Service Bulletin No: 57-018 Ref No: 184

Modification No: EC-19-0354 ATA Chapter: 57

WINGS - WING STRUCTURE REPLACEMENT OF THE ANGLE BRACKETS INSTALLED ON THE LH AND RH WING MIDDLE RIB 23

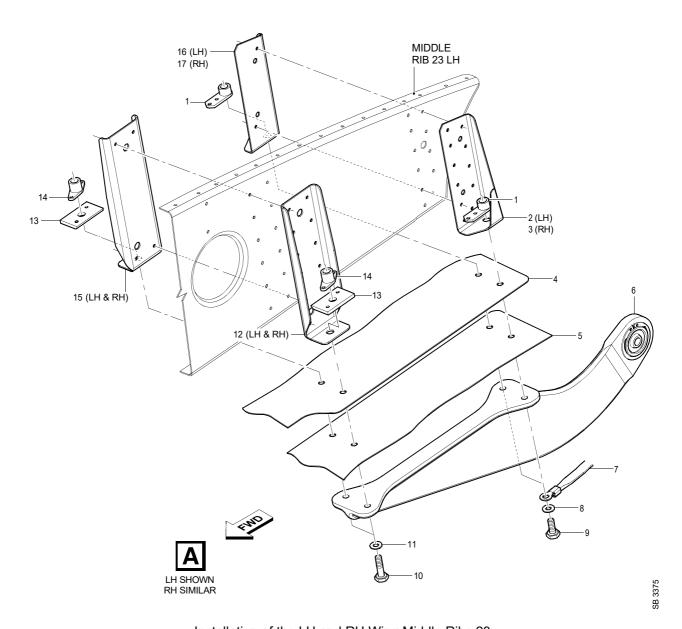
The angle brackets installed on the LH and RH wing middle rib 23 are replaced.

Installation of the LH and RH Wing Middle Ribs 23 Figure 1 (Sheet 1 of 2)

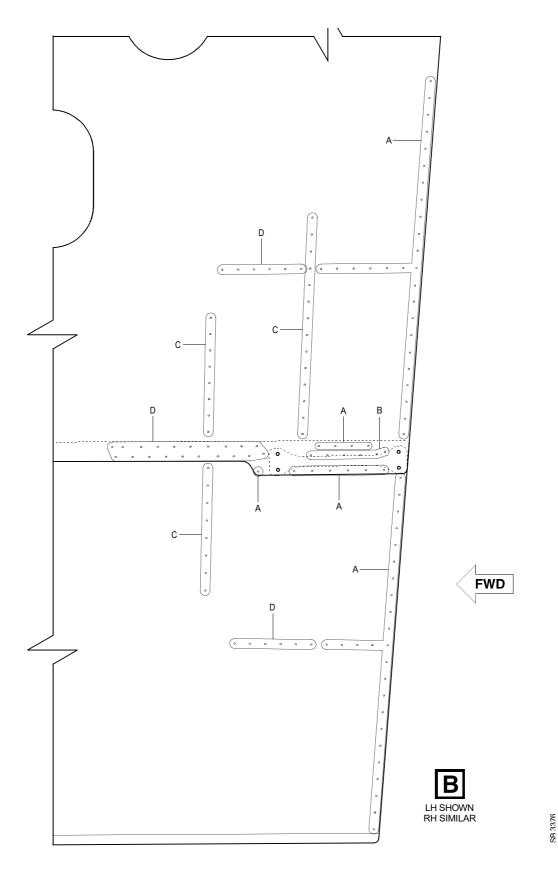
This Service Bulletin gives the data and instructions necessary to replace the angle brackets installed on the LH and RH wing middle rib 23.

- (a) Put the new rib 23 fittings (2) (Pos. No. 3) and (16) (Pos. No. 5) (LH) (or (3) (Pos. No. 4) and (17) (Pos. No. 6) (RH)) in position on the middle rib 23.

- (c) Make sure that the pre-drilled holes in the rib 23 fittings (2) (Pos. No. 3) and (16) (Pos. No. 5) (LH) (or (3) (Pos. No. 4) and (17) (Pos. No. 6) (RH)) align with the existing holes in the middle rib 23.

- (d) Use a 2,4 mm (0.10 in.) diameter drill and make the rivet holes, through the predrilled holes of the new the rib 23 fitting (2) (Pos. No. 3) (LH) (or (3) (Pos. No. 4) (RH)) into:

- The new the rib 23 fitting (16) (Pos. No. 5) (LH) (or (17) (Pos. No. 6) (RH)).
- (e) Use a 3,3 mm (0.13 in.) diameter drill and increase the diameter of the rivet holes in the new rib 23 fittings (2) (Pos. No. 3) and (16) (Pos. No. 5) (LH) (or (3) (Pos. No. 4) and (17) (Pos. No. 6) (RH)).
